174 Palatine rd, West Didsbury, Manchester

Variation application description.

Application number: 134924/JO/2022

Proposal: Variation of condition number 2 (specified plans) from planning approval reference 128895/FO/2020 to allow design changes including the introduction of additional windows and reconfiguration of dormers and roof lights together with amendments to the landscaping scheme incorporating a revised vehicular access to the site and the amendments to the rear car parking.

SOUTH SIDE ELEVATION.

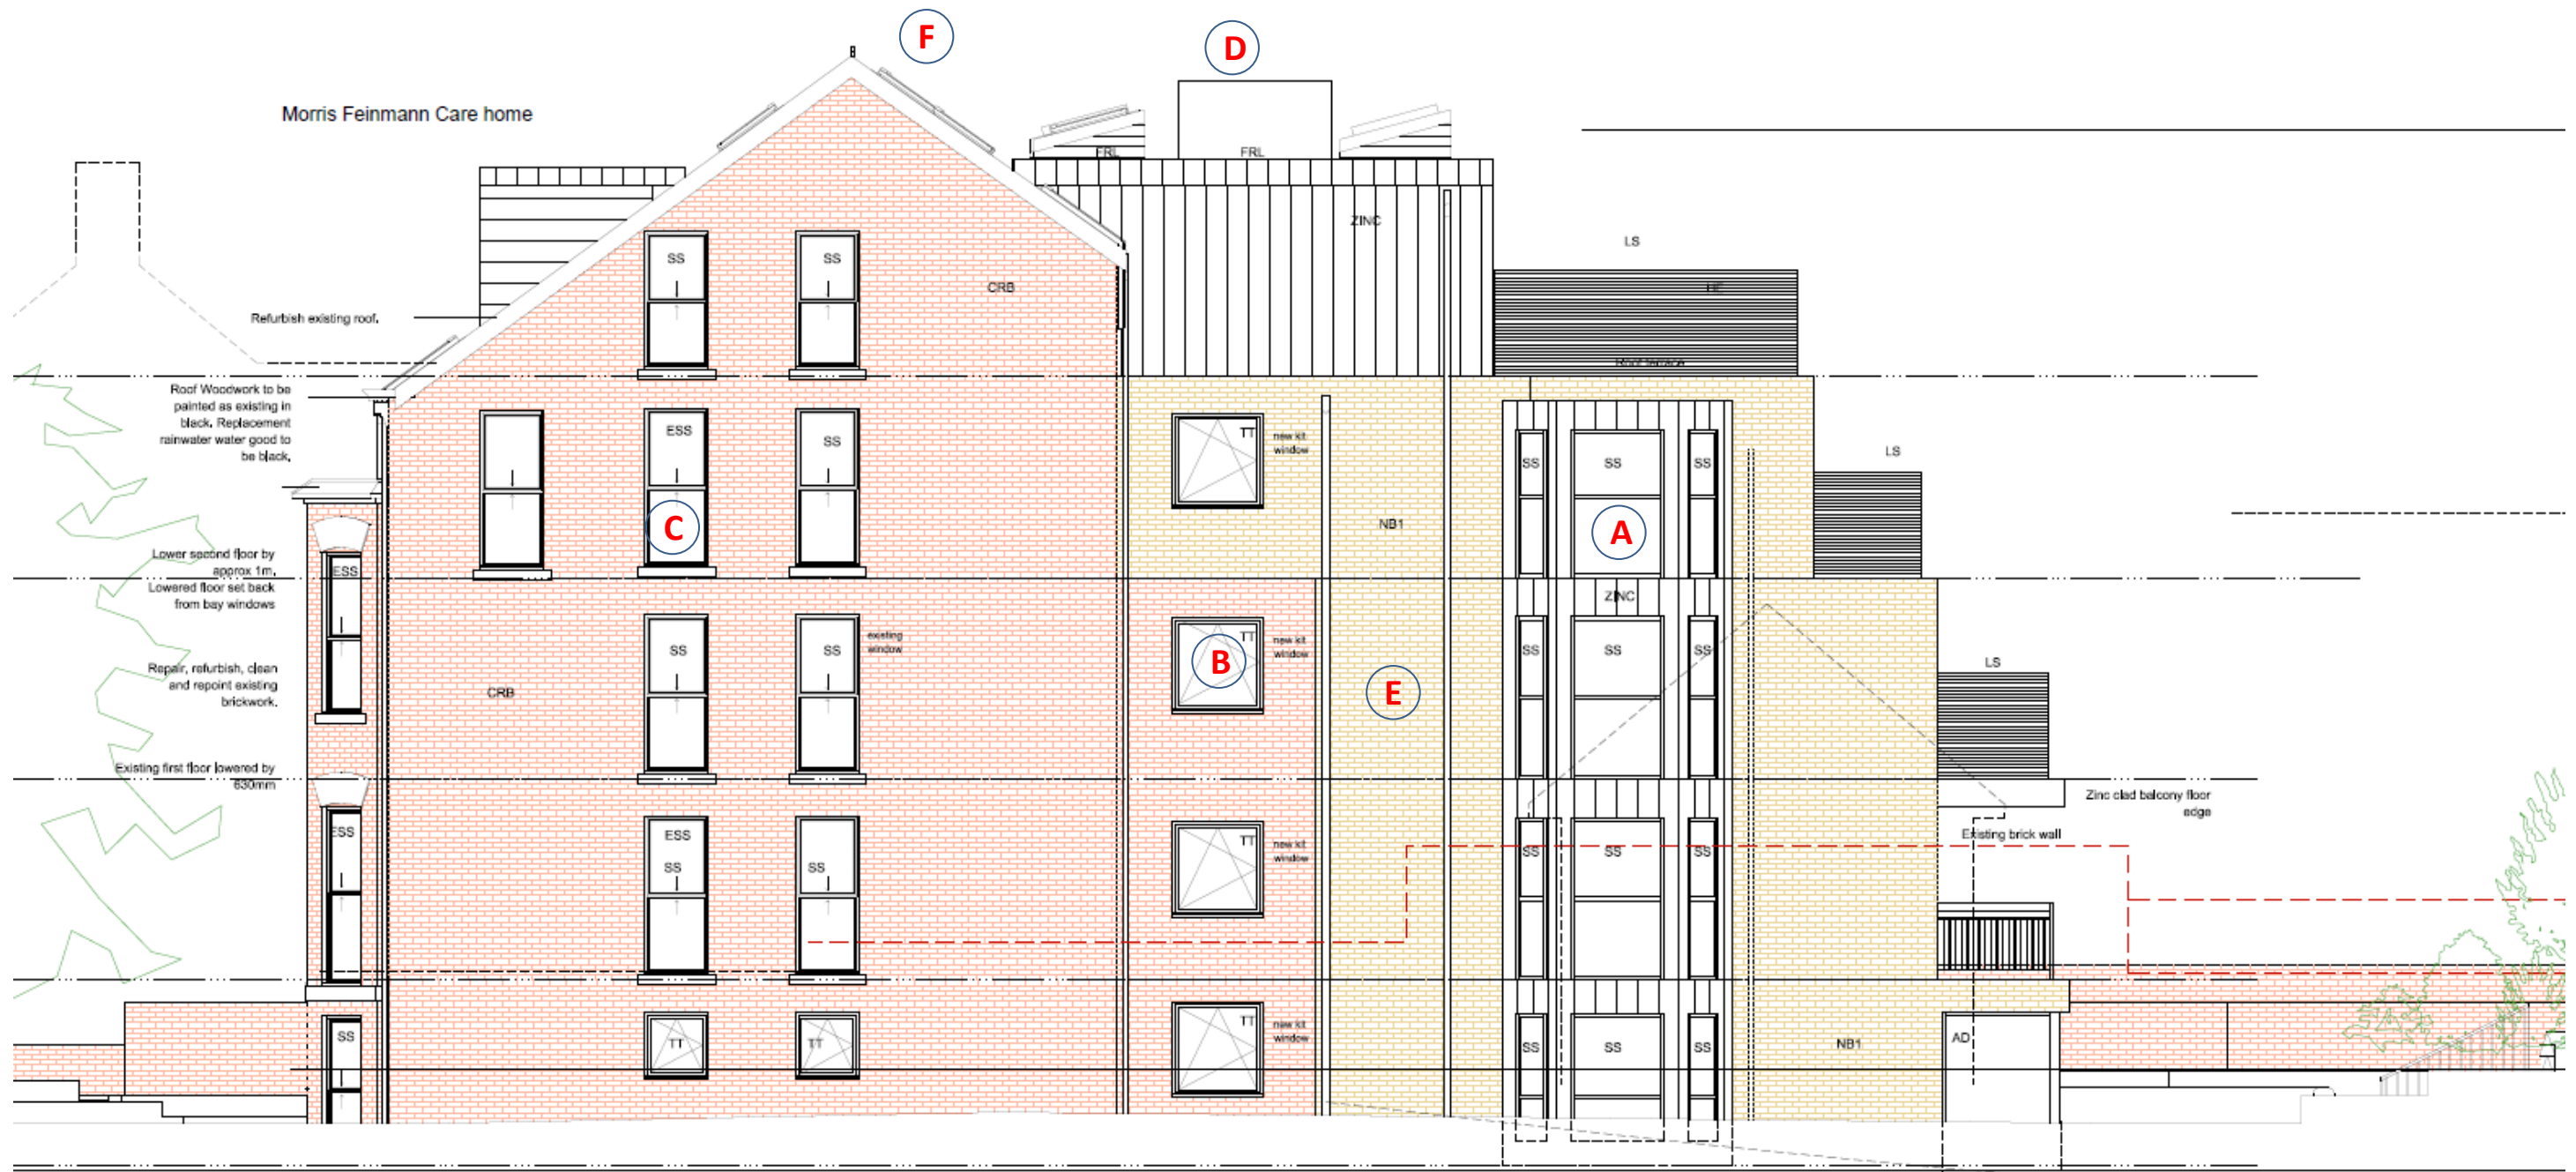
The proposed variation plan has remained almost exactly as the approved plan. The elements that have been revised have been reviewed to improve the quality of the flats by increasing the amount of light that enters the flat and improve the geometric balance of the side elevations.

A: Bay windows added to the South and North Elevation. Proportion and light entering the affected rooms improved.

B: South West facing windows to the living space wrapped around the corner.

C: Window openings to the north and south elevation of the existing building, most of which are existing, will be re-located or added to, a small amount to tidy the elevation geometry. These elevations have become more prominent as the neighbouring sites have changed and are currently disorderly and will benefit from re-locating some of the windows.

D: Requirement for Lift machine room has increased the height of the lift tower.

E: A new Buff brick specified instead of the originally specified red brick.

F: Unmaintained, dangerous leaning chimneys removed

NORTH SIDE ELEVATION.

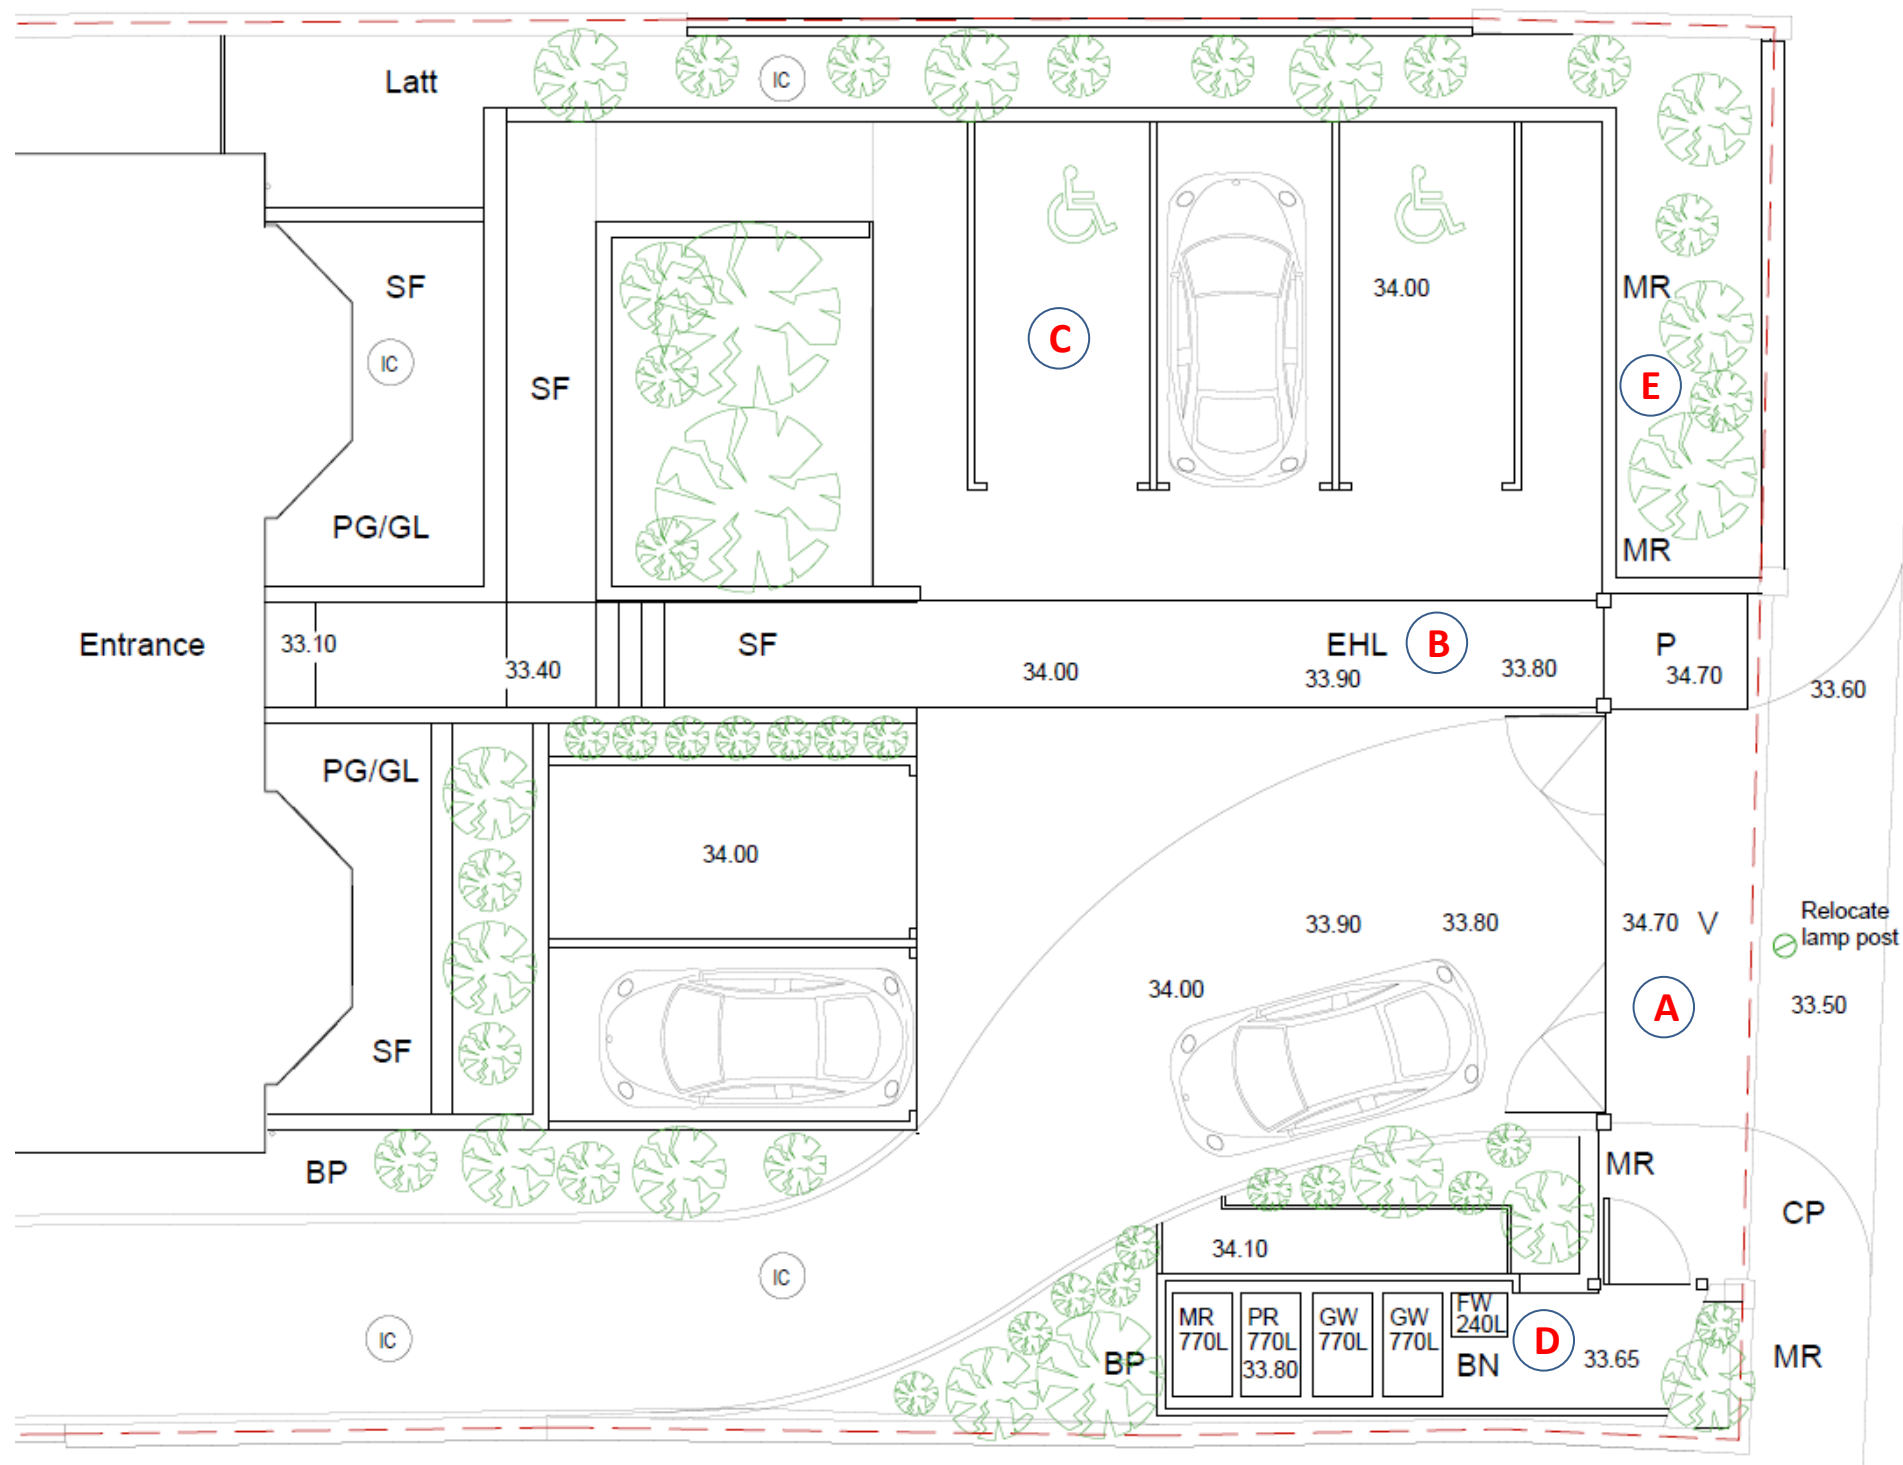
The proposed variation plan has remained almost exactly as the approved plan. The elements that have been revised have been reviewed to improve the quality of the flats by increasing the amount of light that enters the flat and improve the geometric balance of the side elevations.

A: Bay windows added to the South and North Elevation. Proportion and light entering the affected rooms improved.

B: North Facing Kitchen windows enlarged and re-shaped.

C: Window openings to the north and south elevation of the existing building, most of which are existing, will be re-located or added to, a small amount to tidy the elevation geometry. These elevations have become more prominent as the neighbouring sites have changed and are currently disorderly and will benefit from re-locating some of the windows.

D: Requirement for Lift machine room has increased the height of the lift tower.

E: A new Buff brick specified instead of the originally specified red brick.

F: Unmaintained, dangerous leaning chimneys removed.
